CITY COUNCIL

MEETING DATE: Tuesday July 28, 2020

SUBJECT: Request to revise an Approved Preliminary Plat for Royal Pines (Formerly Diamonds Keep) Subdivision Phase 5, located off of Archdale Road and being Randolph County parcel # 7726496982.

REVISED PRELIMINARY PLAN
FOR
ROYAL PINES SUBDIVISION
ARCHDALE ROAD (NCSR 1004)
DEVELOPED BY
KEYSTONE GROUP, INC.
CITY OF ARCHDALE
RANDOLPH COUNTY – NORTH CAROLINA

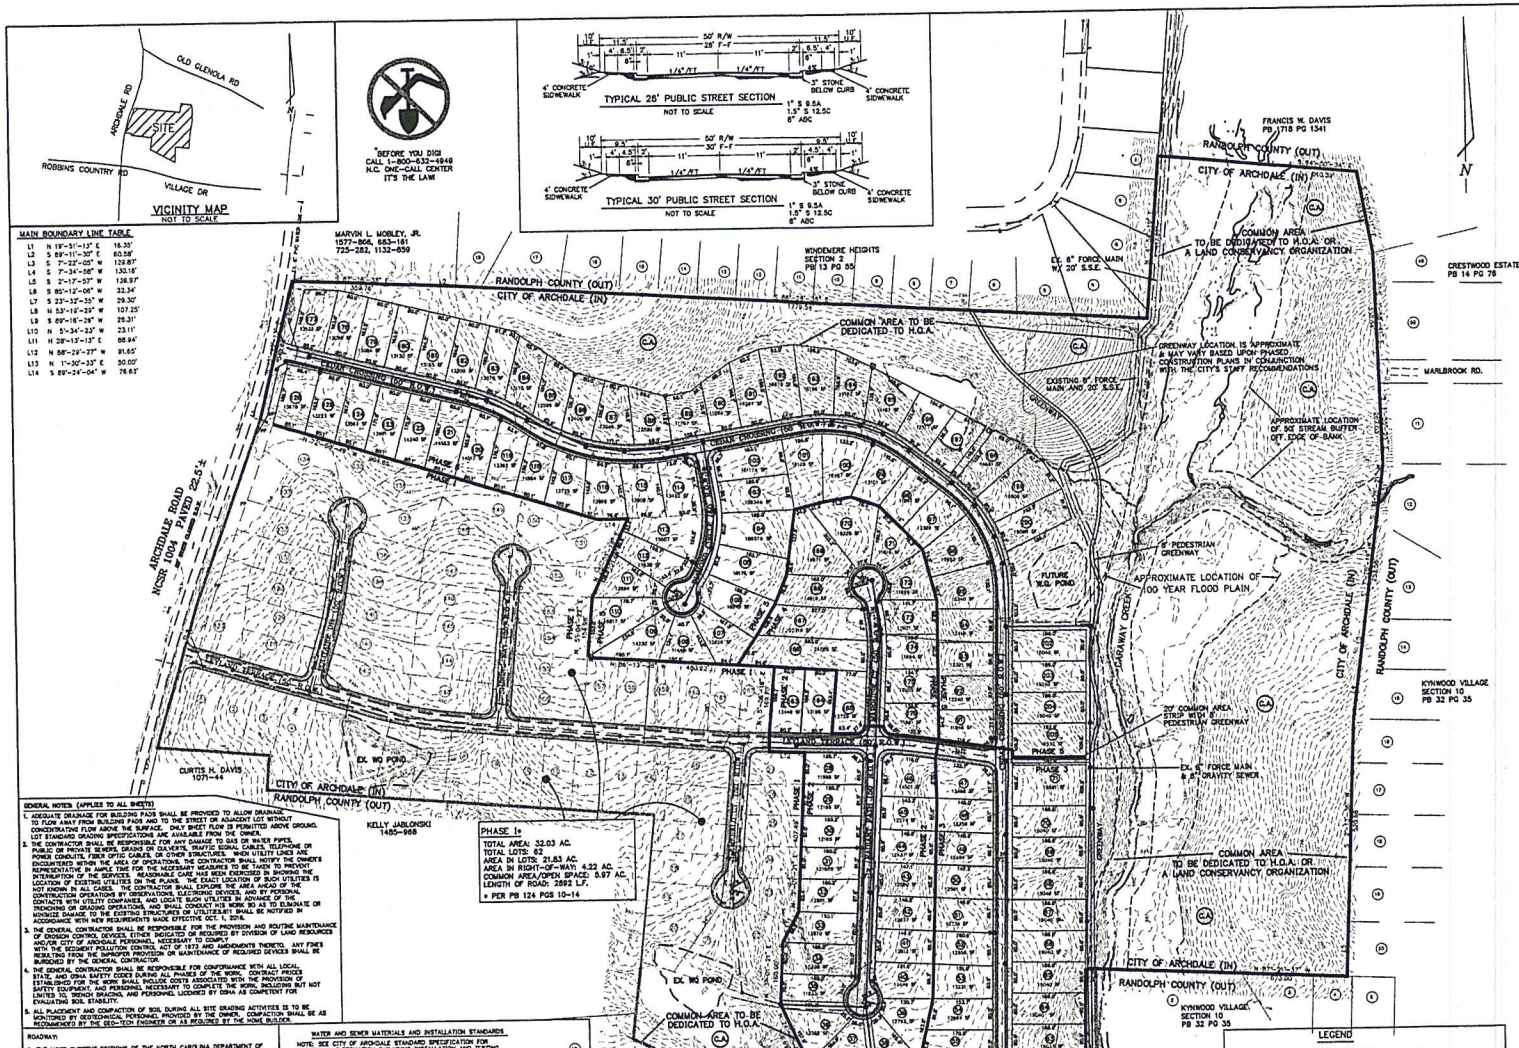
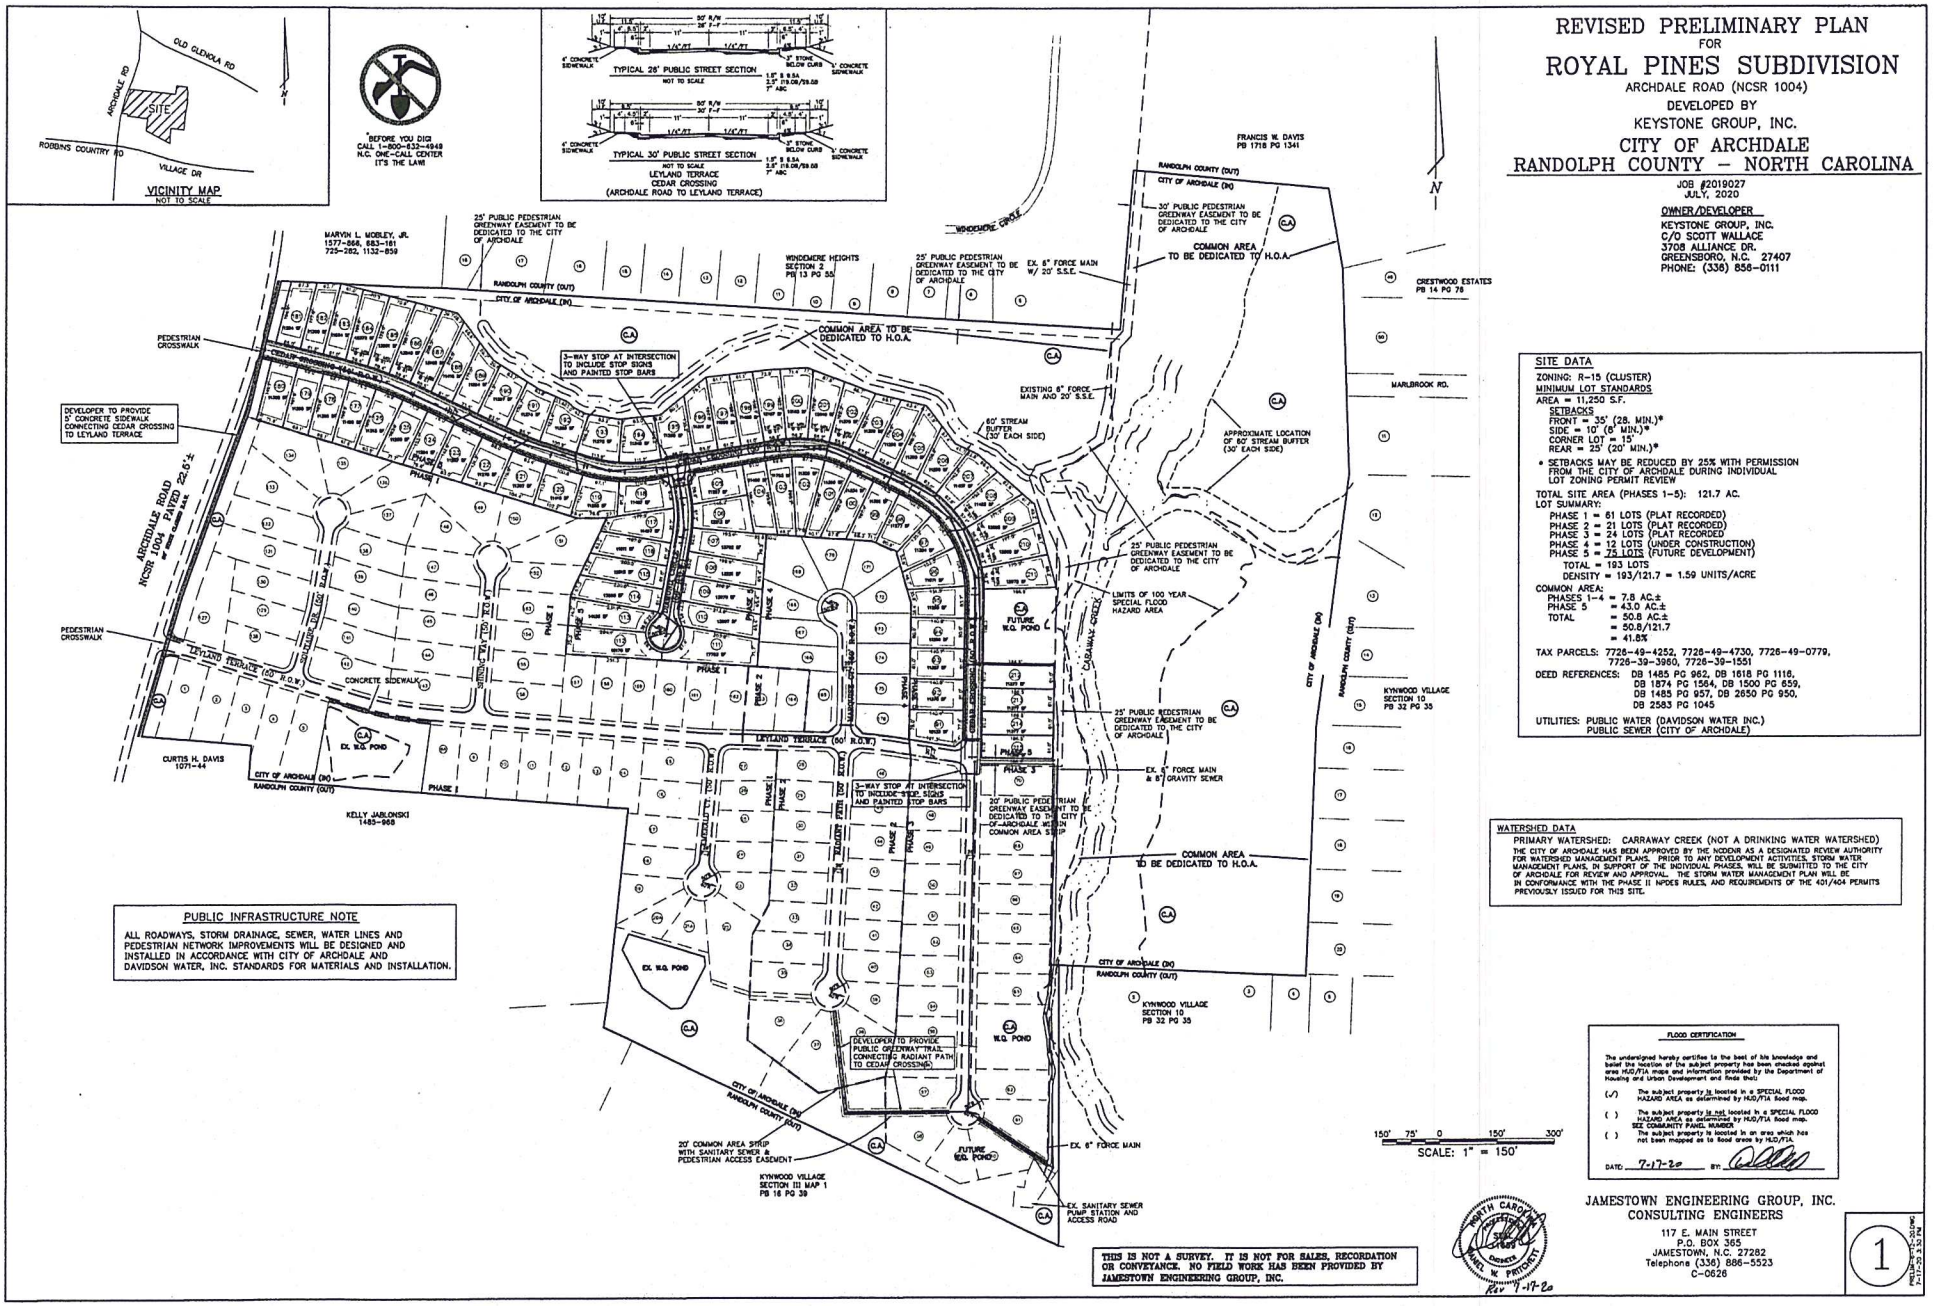
There are minimal changes to the proposed site plan. The developer is seeking to add 11 lots to Phase 5, increasing the number of buildable lots to 75. To mitigate traffic, 3-Way Stop Signs will be installed at intersections along Cedar Crossing. Additional revisions pertain to pedestrian infrastructure within the subdivision. The developer will construct a greenway trail connecting Radiant Path to Cedar Crossing, and provide public pedestrian greenway easements along the northern, and western boundaries of the property for future expansion of the greenway system. Sidewalks are located on both sides of the streets that are 30 feet in width, and on one side for streets that are 26 feet in width. Additional sidewalk will be installed along Archdale Road for the length of property, providing a pedestrian loop and connecting Cedar Crossing to Leyland Terrace; pedestrian crosswalks will be installed at both entrances.

The proposed plat revision was reviewed by all members of the Technical Review Committee (TRC). The NCDOT required that left and right turn lanes be installed on Archdale Road. A previous traffic impact analysis was conducted for the proposed residential subdivision; the analysis showed that Archdale Road should effectively handle additional traffic from the subdivision, with the installation of turn lanes and two entrances. A homeowner's association has been established as required for the dedicated open space, and for drainage easements. The property is zoned R-15 and meets the dimensional requirements for an R-15 cluster subdivision. The minimum lot area for a single-family lot in an R-15 cluster subdivision is 11, 250 square feet. When added to the 182 lots in Phases 1 through 4, Phase 5 will complete the Royal Pines Subdivision. Staff recommends approval of the request.
